SAFETY EVALUATION  
BY THE  
DIRECTORATE OF LICENSING  
U. S. ATOMIC ENERGY COMMISSION  
IN THE MATTER OF  
DUKE POWER COMPANY  
OCONEE NUCLEAR STATION UNITS 2 AND 3  
DOCKET NOS. 50-270/287

July 6, 1973

FIGURE 7-1

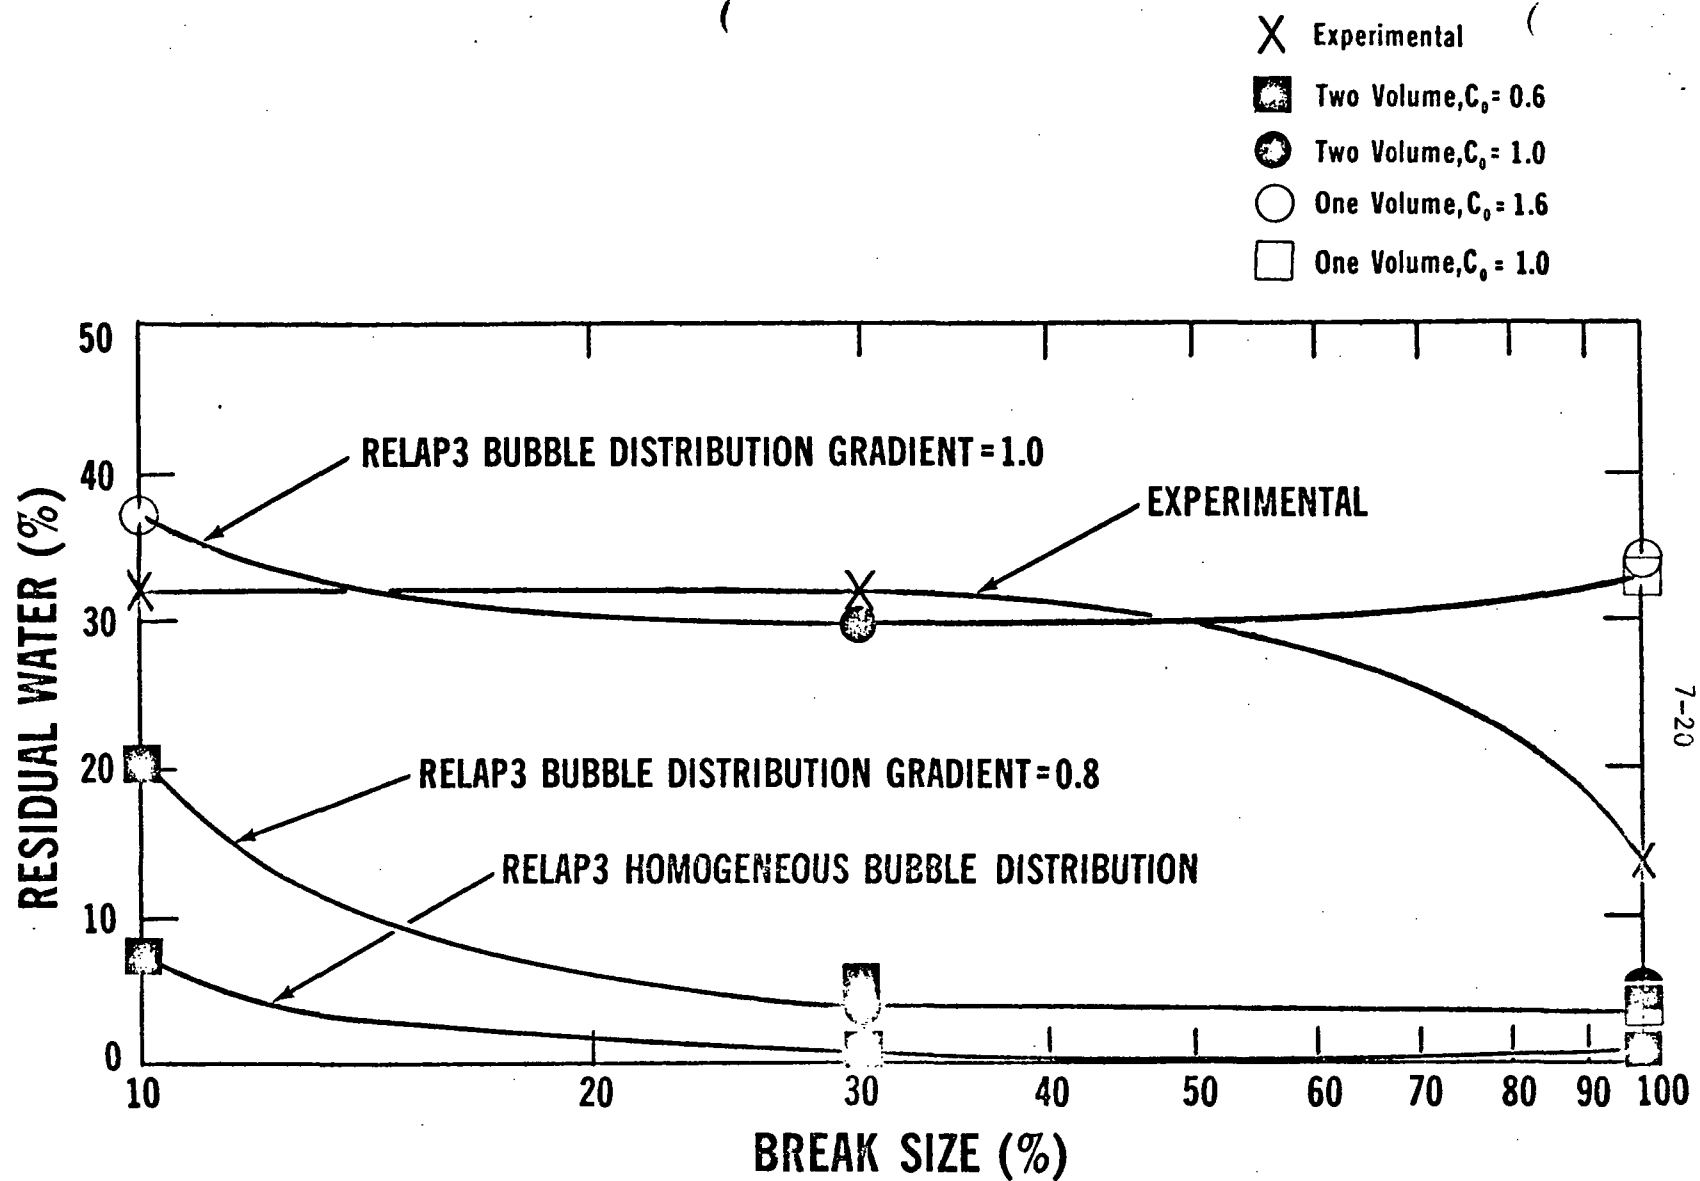
Further support for the use of a bubble rise model was given in an Idaho Nuclear Corporation report (Report IN 1444, December 1970). In this report the RELAP code was used to predict results obtained from a semi-scale blowdown experiment. Figure 7-1 was taken from IN 1444 and shows that the residual water remaining in a vessel after the end-of-blowdown was best predicted by using a bubble rise model. The figure indicates that the density gradient should be between 0.8 and 1.0 with a bubble rise velocity of 3 ft/sec. Based on these results and calculations performed by the staff, a bubble rise model better predicts the actual system response.

One other conclusion drawn by B&W was that the CFT line break never led to an end-of-blowdown (as defined in the B&W evaluation model for a large break). In the downcomer noding studies performed by the staff it was concluded that end-of-blowdown could be calculated to occur by selecting 4 axial nodes in the downcomer and using a homogeneous assumption in all nodes. The end-of-blowdown occurred at about 120 seconds. The end-of-blowdown occurred because the cold core flood tank water entered into a node containing steam, which was then condensed, thus reducing the pressure below containment pressure. This node also contained the broken CFT line such that the reduction in pressure caused the break flow to go to zero (the definition of end-of-blowdown). This effect was investigated using the REDUCED MODEL with 2 axial nodes in the downcomer. An end-of-blowdown was

FIGURE 7-2

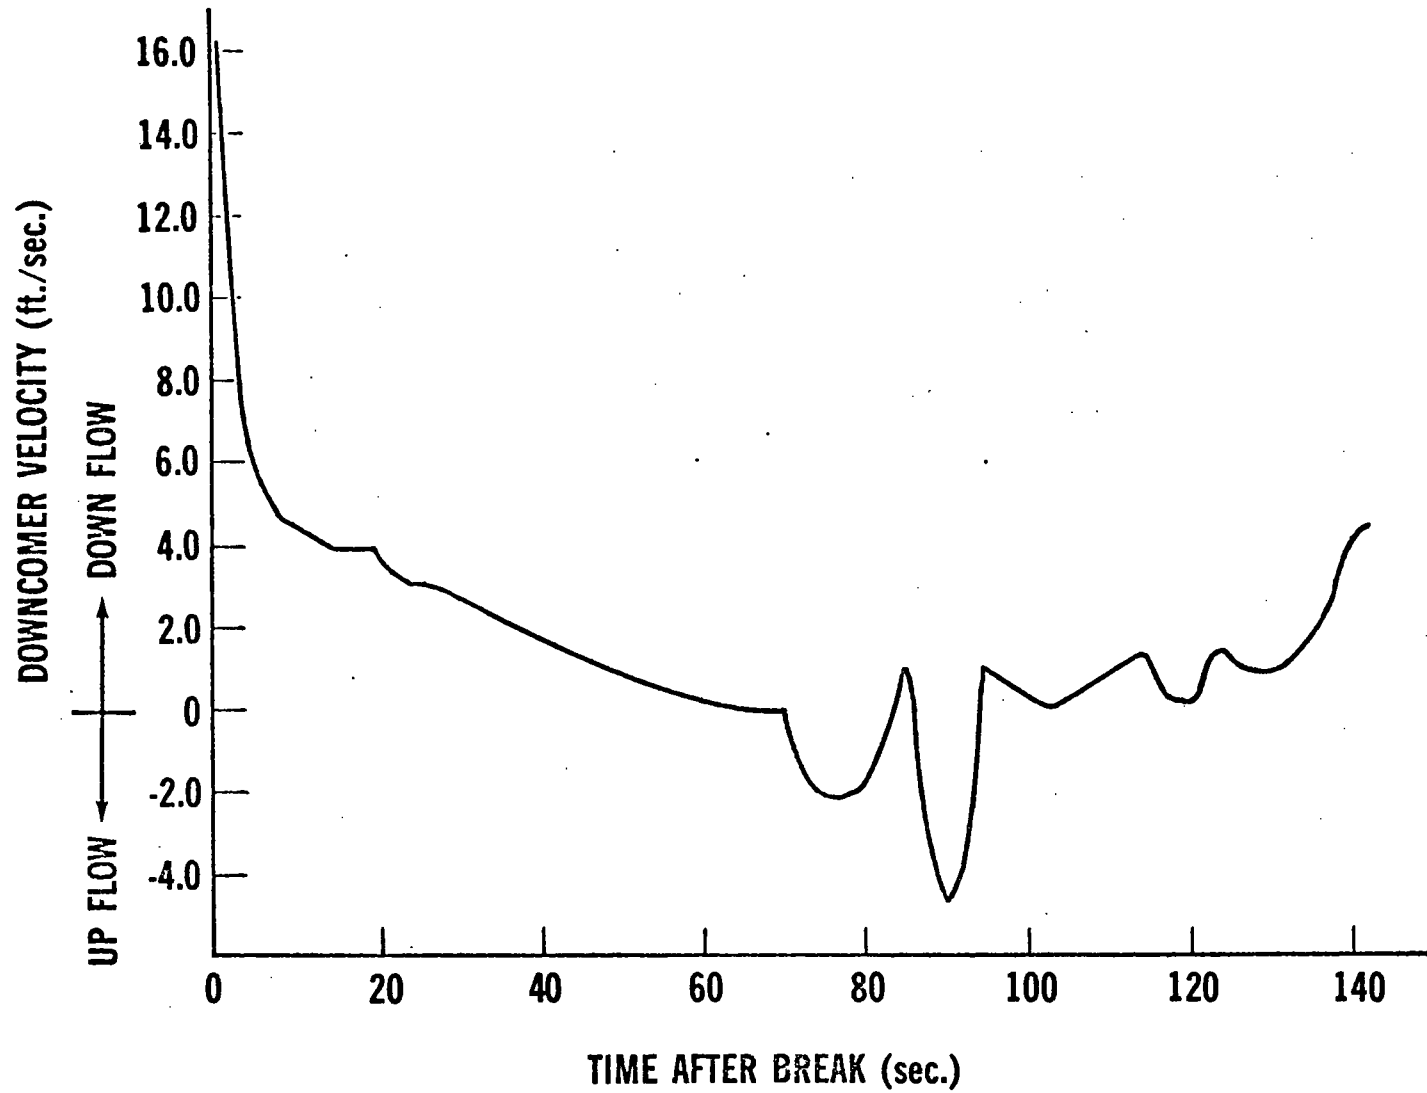
One assumption used by B&W was that the accumulator bypass criterion should not apply to the CFT line break. B&W gave two reasons for making this change. The first was that the system pressure for the CFT line break never reached the end-of-blowdown criterion; the second reason was that the fluid velocity in the downcomer was always downward, except for short time periods. During these time periods the calculated velocities were low (maximum negative velocity was approximately 4 ft/sec). These low velocities do not cause any significant amount of ECC water to be entrained out the break. In the staff independent evaluation the same velocity effect was seen. A plot of downcomer velocity is presented in Figure 7-2 for a single node downcomer using a homogeneous assumption. This

figure shows a maximum velocity of  $\sim 4$  ft/sec for approximately 25 sec. Analysis reported by B&W using a three node downcomer and using a bubble rise model (also calculated by RELAP in the independent analysis) showed that the maximum negative velocity was approximately 4 ft/sec for about 100 sec. Critical velocity for entrainment from an annular film is about 13 ft/sec at 300 psia using the Wallis correlation (Ref. 4) given below.

additional water should be supplied at a rate which would insure that the core would be reflooded at a reasonable rate.

To supply this additional water, the applicant instituted operating procedures to be used in the event of a LOCA. These procedures ensure that water from the low pressure injection (LPI) system is delivered into the reactor vessel for this accident. The operator is required to take action to rearrange the valving in the LPI system such that at least one-half the flow rate from the LPI pumps is injected into the vessel. This amount of additional water assures that an abundant supply of cooling water is available to reflood the core and remove stored and decay heat.
